In the matter of                      of a Board of Inquiry appointed under s 149J of the Resource Management Act to consider Notices of Requirements and resource consents made by the New Zealand Transport Agency in relation to the East West Link roading proposal in Auckland,

**Statement of evidence of David William Arthur Mead**

Dated 22 May 2017

Figure 6: Foreshore Before and After

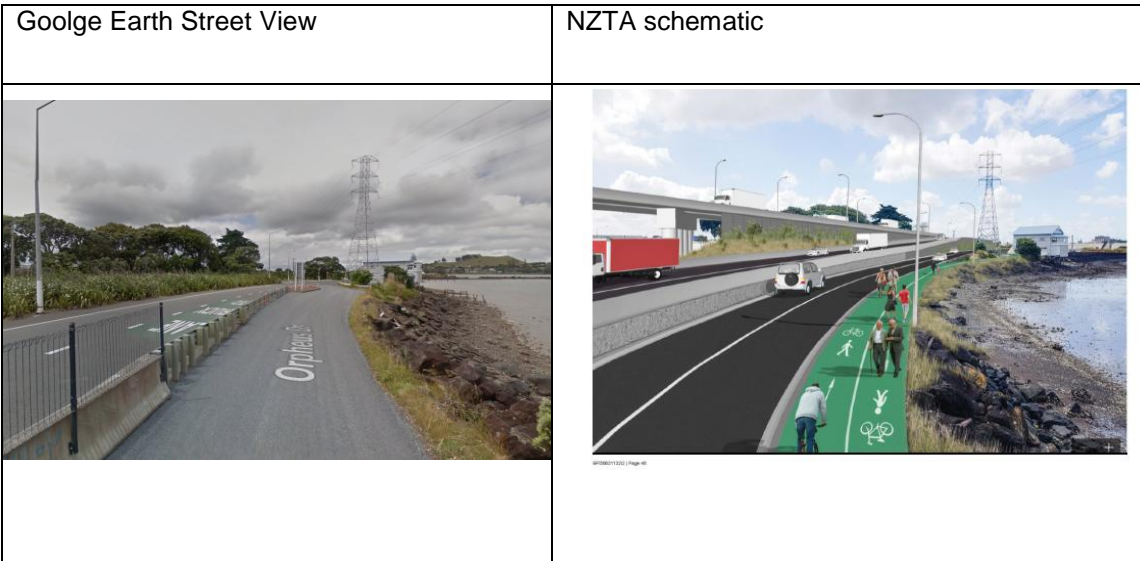
- 62 The indicative image appended to Ms Hancock's evidence (Annexure C) is instructive as to the changes to the environment of the foreshore area and the extent to which the new infrastructure is squeezed into the space between the foreshore and the existing motorway alignment. I do not see how the new arrangement can be claimed to be a benefit.
- 63 There is no corresponding 'before' shot in Ms Hancock's evidence. Below I provide side-by-side a Google earth screen shot of the same view, and the schematic representation provided by Ms Hancock.

- 71 My assessment of urban design and planning effects (that are not well described in the AEE and that are significant prior to consideration of mitigation), are as follows:

- a The new elevated roading and bridging proposed will separate the Te Hōpua tuff ring from the Manukau Harbour. This will weaken the natural character of the coastal environment

- b The proposed shared pedestrian and cycle path between Onehunga Wharf and Taumanu reserve appears to lack the width and quality consistent of the paths and environment in Taumanu reserve and on the intended coastal path along the Māngere Inlet. Yet this is likely to be one of the most highly used paths / linkages in the area

- c The shared path will be adjoined by a series of parallel roads which rise above the grade of the shared path and which will physically dominate the route. This will cause noise, air pollution and amenity effects that will degrade the quality of this area

65 Figure 7: Cross sections

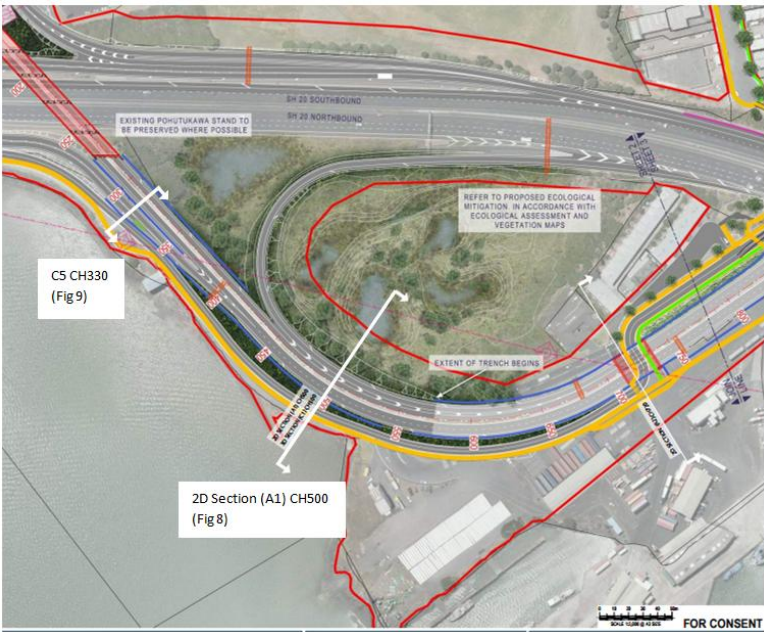
64 The cross sections below provided by NZTA further illustrate the point. Figure 7 shows the location of two different cross sections provided.

Figure 9: Cross Section 5

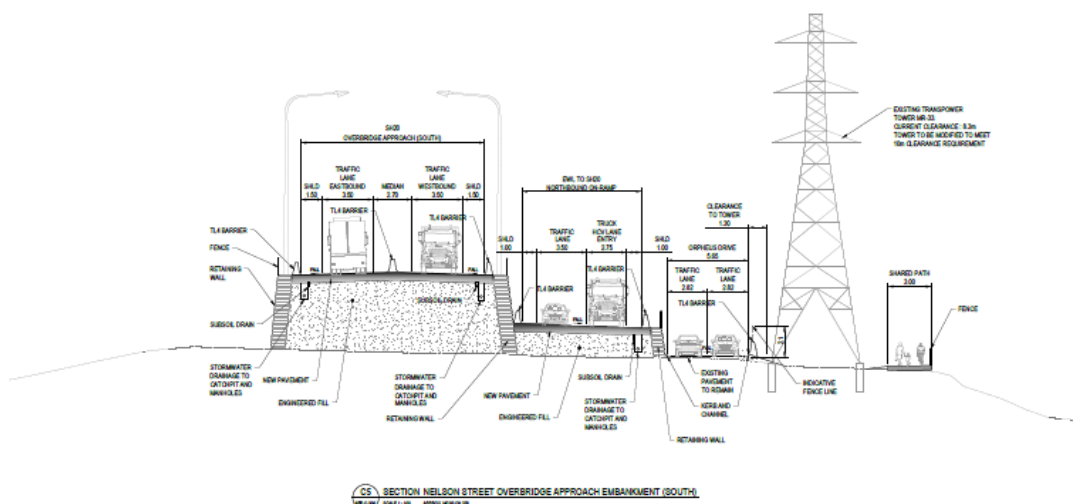
67 This cross section appears to be taken where there is the greatest space between the new coastal footpath and the new motorway, in the section from Taumanu to the wharf. The cross section below is nearer the Sea Scouts building, where the walkway deviates around a pylon.
